**AREA 2 FIELD SAMPLING PLAN**

**ADDENDUM TO REMEDIAL INVESTIGATION**

**FORMER FORT DEVENS ARMY INSTALLATION, DEVENS, MA**

**DECEMBER 2018**

Figure  
3

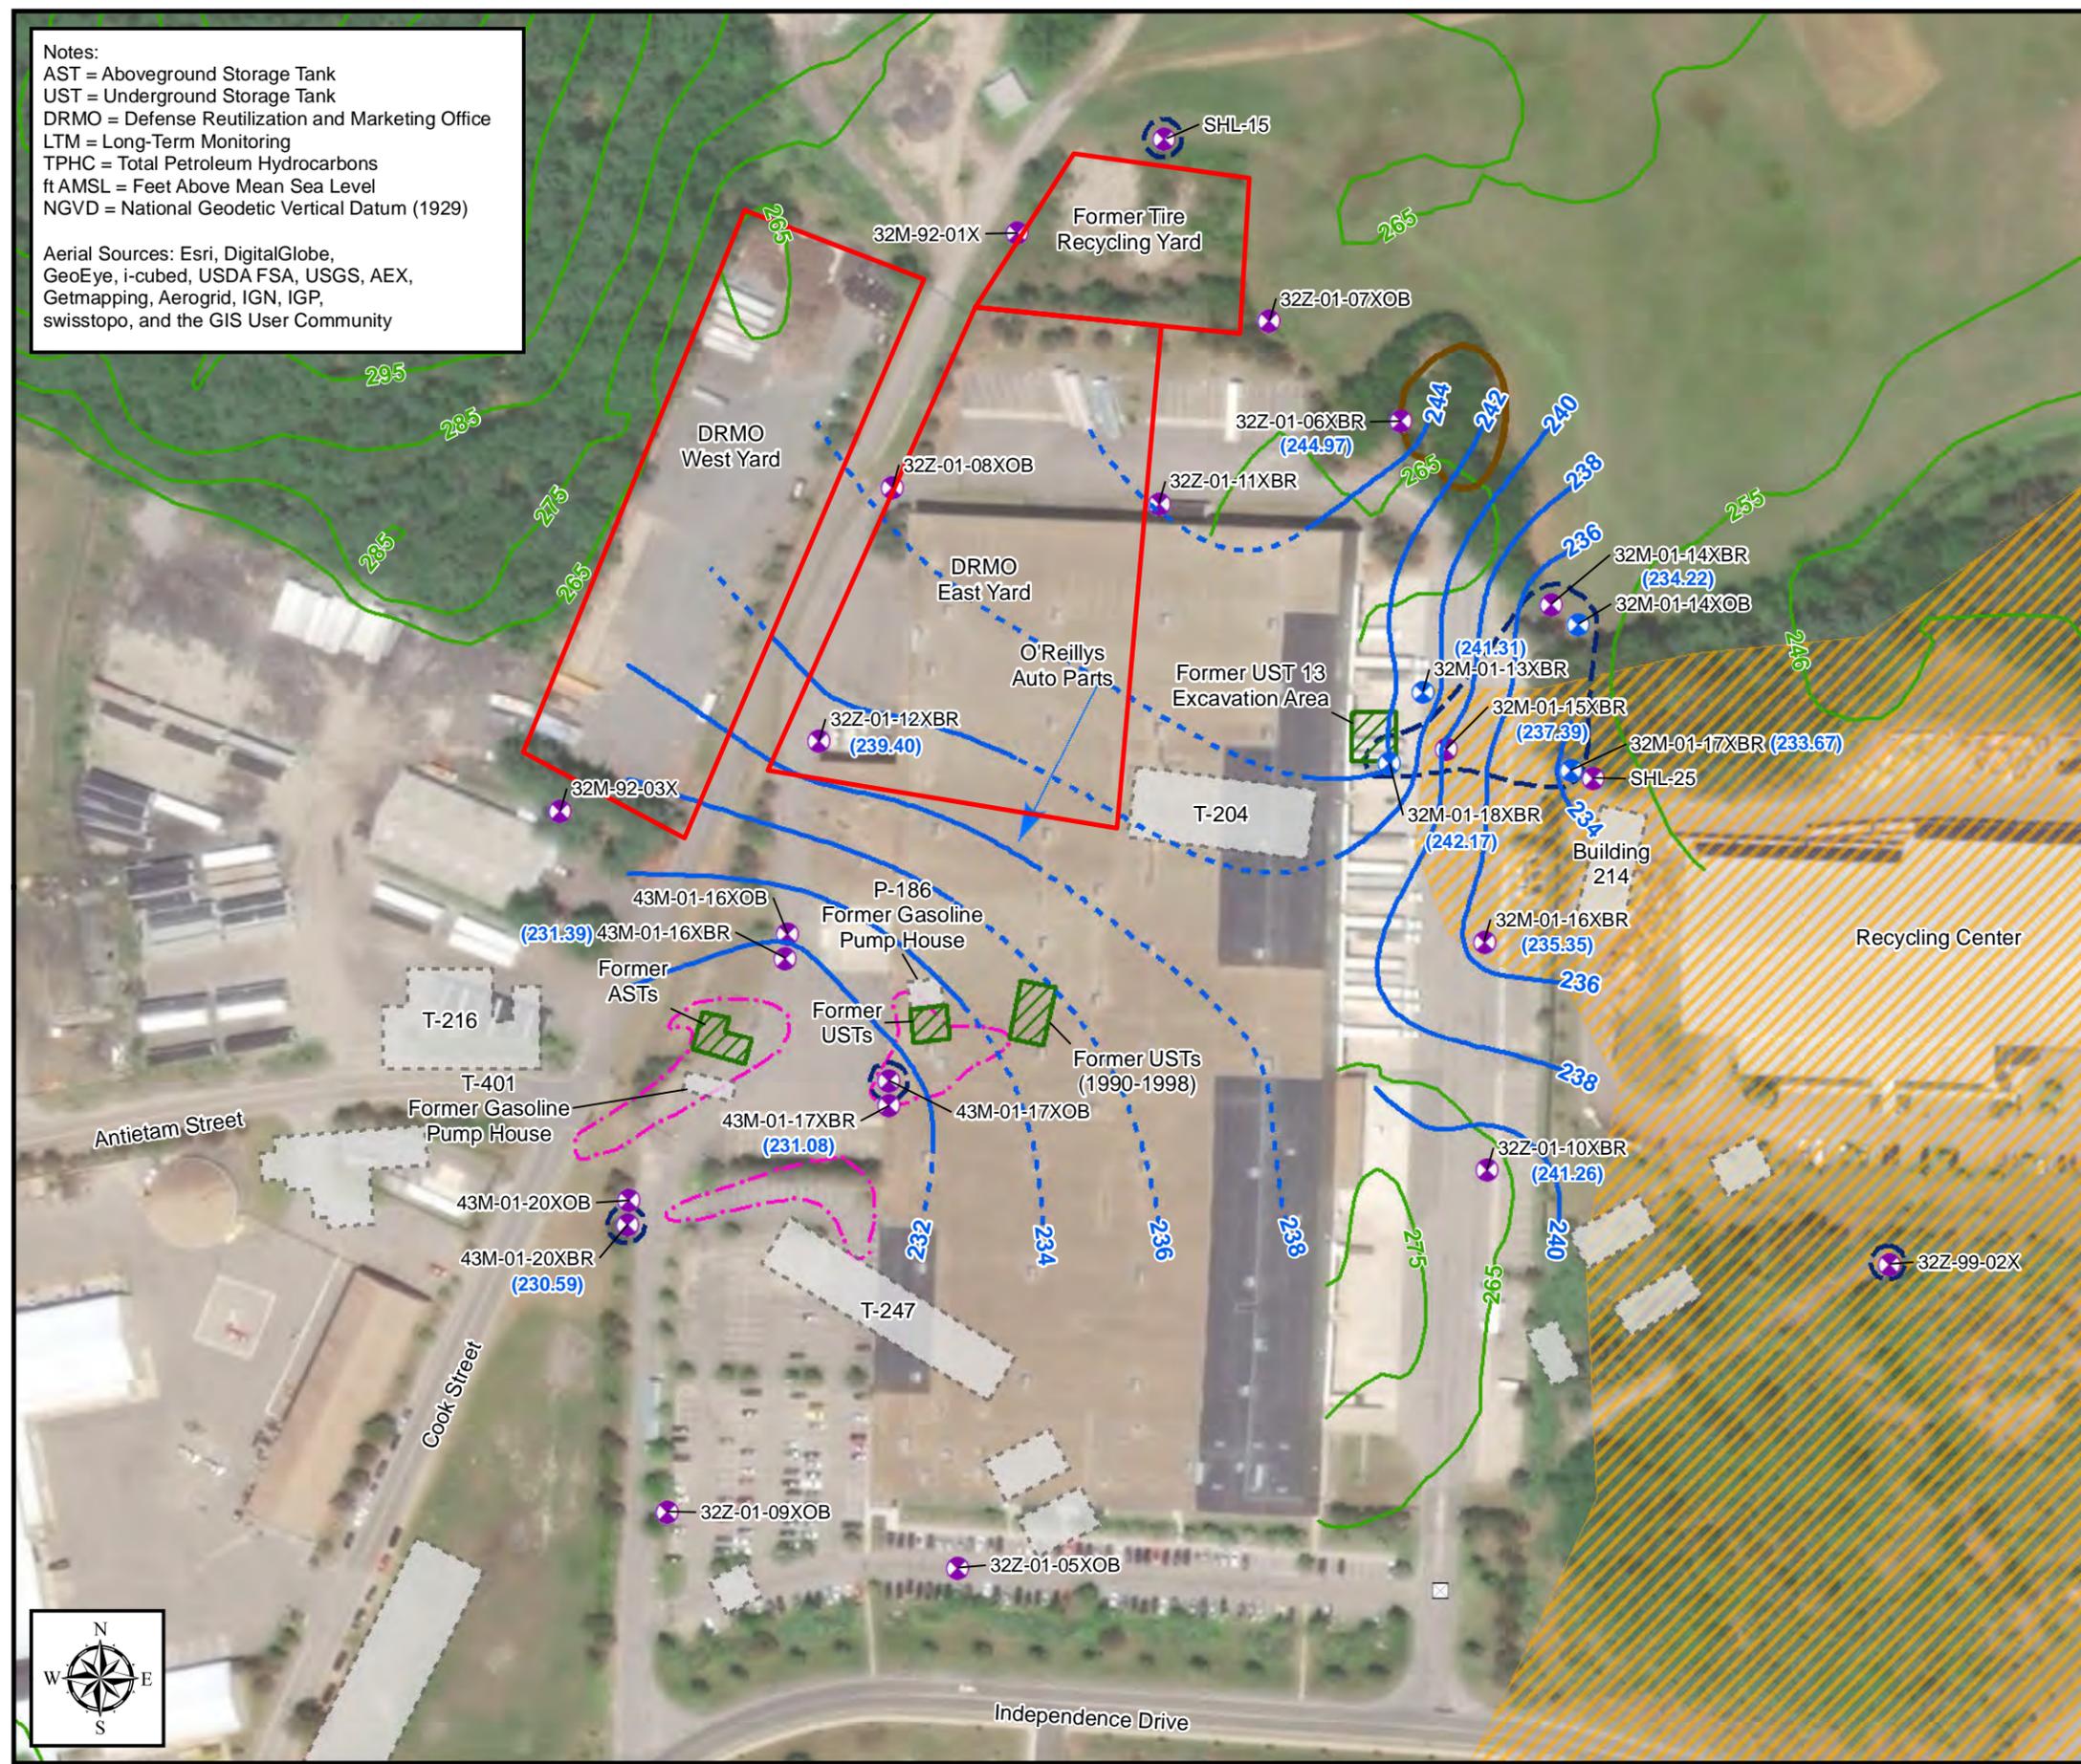
**Comment # 8:** Figure 3, AOC32/43A - Please edit the figure to outline the extents of the storage areas (east, west, and tires).

**Comment # 9:** Figure 3, AOC32/43A - Based on the water level data presented, the 234 contour looks questionable and could potentially extend to the northeast. The justification for the contour as presented is unclear. Also, 32Z-01-05XOB water level data appears to be a significant anomaly; is there other data supporting that water level?

**Response:** The extents of the storage areas will be added to Figure 3.

**Response:** The 2017 water table elevations in overburden wells at AOC 43A are anomalous from previous depictions of water table elevations in overburden wells at AOC 43A. Historically, the shape of groundwater contours developed from overburden wells are similar to the groundwater contours developed from bedrock wells. Figures 3 and 4 will be revised to show the 2016 interpreted water table elevations as the 2016 elevations are more indicative of historic conditions.

Figure  
5

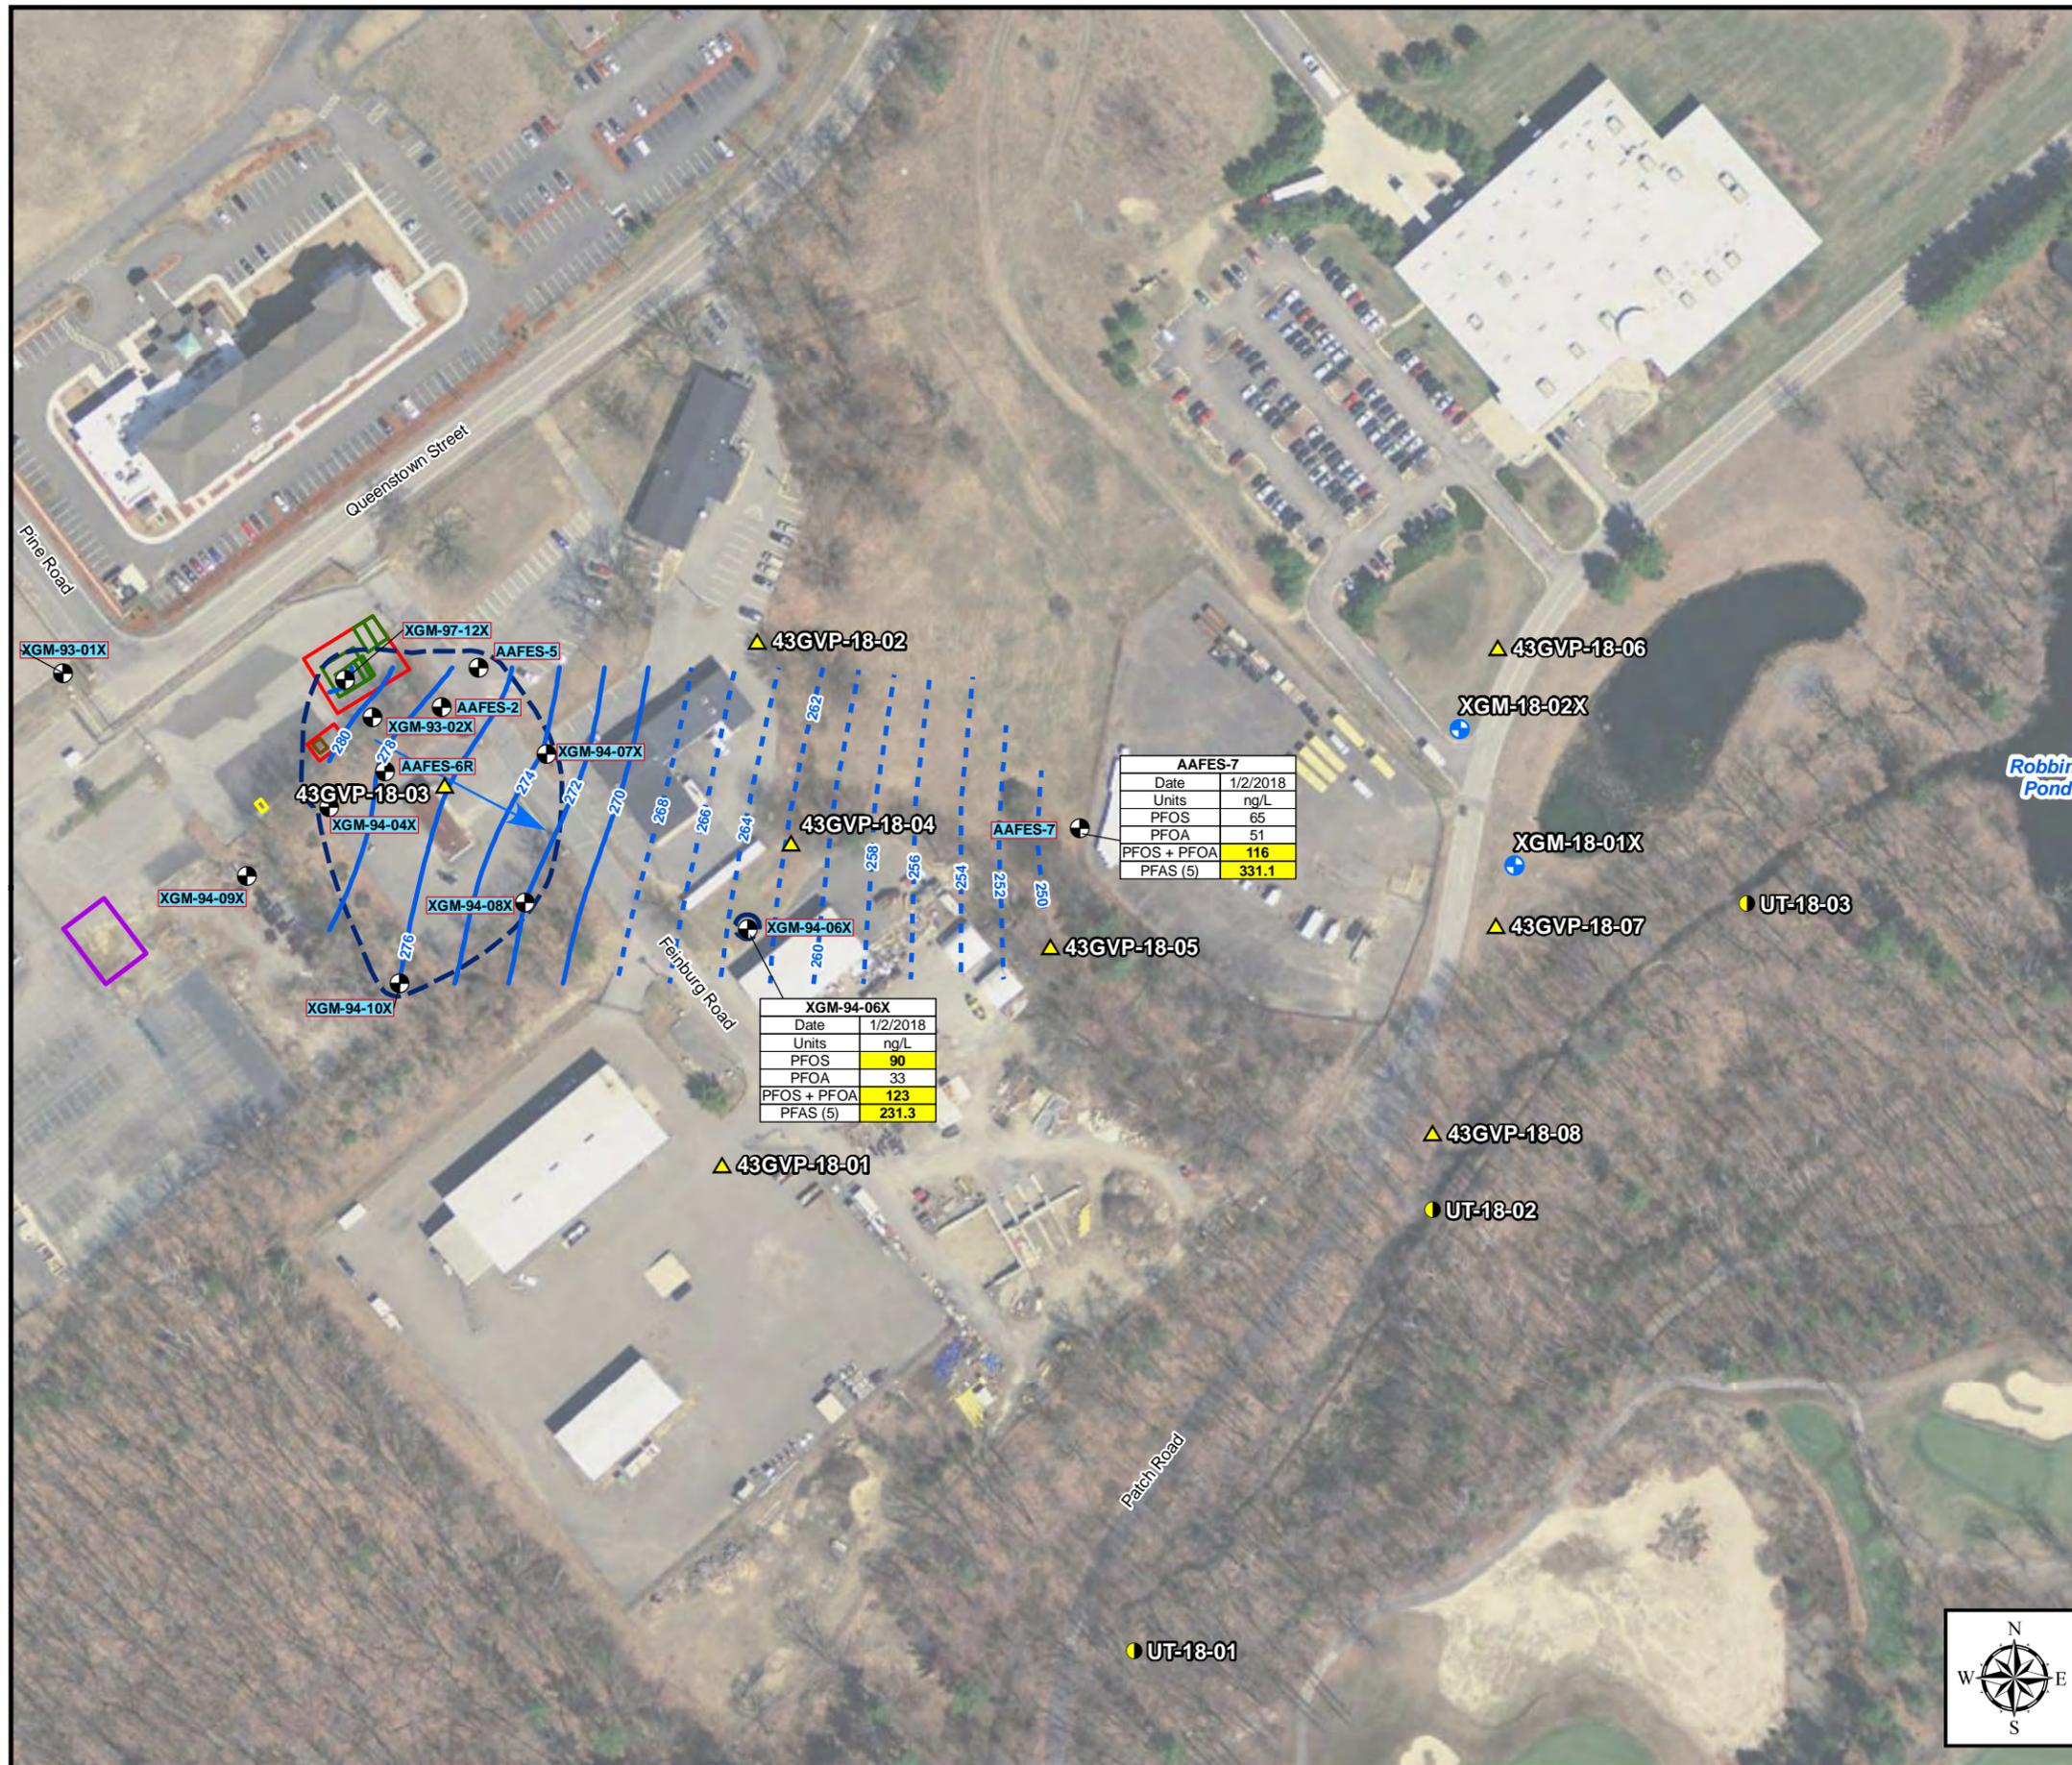
**Comment # 10:** Figure 5, AOC32/43A – During groundwater sampling conducted during the SI, monitoring well 32Z-01-07XOB had a PFAS concentration in excess of the LHA. However, based on the groundwater flow directions shown in Figure 3, there is no monitoring proposed that is suitable for detecting PFAS downgradient of this well. EPA recommends that another vertical profile location east of 32Z-01-07XOB be installed/sampled. Note also that the groundwater flow path east of 32Z-01-07XOB is not well defined.

**Comment # 11:** Figure 5, AOC32/43A - EPA notes that there are no wells proposed on the flow path from the DRMO East Yard southeast/south past the former building T-204. This appears to be a data gap that needs to be addressed to rule out the East Yard as a PFAS source. A vertical profile location should be added along this flow path.

**Comment # 10:** Figure 5, AOC32/43A – During groundwater sampling conducted during the SI, monitoring well 32Z-01-07XOB had a PFAS concentration in excess of the LHA. However, based on the groundwater flow directions shown in Figure 3, there is no monitoring proposed that is suitable for detecting PFAS downgradient of this well. EPA recommends that another vertical profile location east of 32Z-01-07XOB be installed/sampled. Note also that the groundwater flow path east of 32Z-01-07XOB is not well defined.

**Comment # 11:** Figure 5, AOC32/43A - EPA notes that there are no wells proposed on the flow path from the DRMO East Yard southeast/south past the former building T-204. This appears to be a data gap that needs to be addressed to rule out the East Yard as a PFAS source. A vertical profile location should be added along this flow path.

**Response:** A review of the groundwater contours presented on Figure 3 of the Area 2 FSP indicates that monitoring wells, 32Z-01-06XBR, 32M-01-14XBR, 32M-01-14XOB, N7-P1, N7-P2 and SHL-12, are located hydraulically downgradient of monitoring well 32Z-01-07XOB. Due to the uncertainty in groundwater flow direction to the east of 32Z-01-07XOB, monitoring wells along several potential flow paths from this well were selected for sampling. The data obtained from these monitoring wells, coupled with the vertical profiling data obtained at 32VP-18-02 is expected to provide data sufficient to delineate the vertical and lateral extent of PFAS in the aquifer located downgradient of monitoring well 32Z-01-07XOB.

**Response:** A review of the groundwater contours presented on Figure 3 of the Area 2 FSP indicates that monitoring wells, 32Z-01-06XBR, 32M-01-14XBR, 32M-01-14XOB, N7-P1, N7-P2 and SHL-12, are located hydraulically downgradient of monitoring well 32Z-01-07XOB. Due to the uncertainty in groundwater flow direction to the east of 32Z-01-07XOB, monitoring wells along several potential flow paths from this well were selected for sampling. The data obtained from these monitoring wells, coupled with the vertical profiling data obtained at 32VP-18-02 is expected to provide data sufficient to delineate the vertical and lateral extent of PFAS in the aquifer located downgradient of monitoring well 32Z-01-07XOB.

**Follow-On Response:** A vertical profile location, 32VP-18-08, will be added between 32Z-01-10XBR and 32Z-01-05XOB. Figures 2 and 5 and Tables 5 and 6 will be revised accordingly.
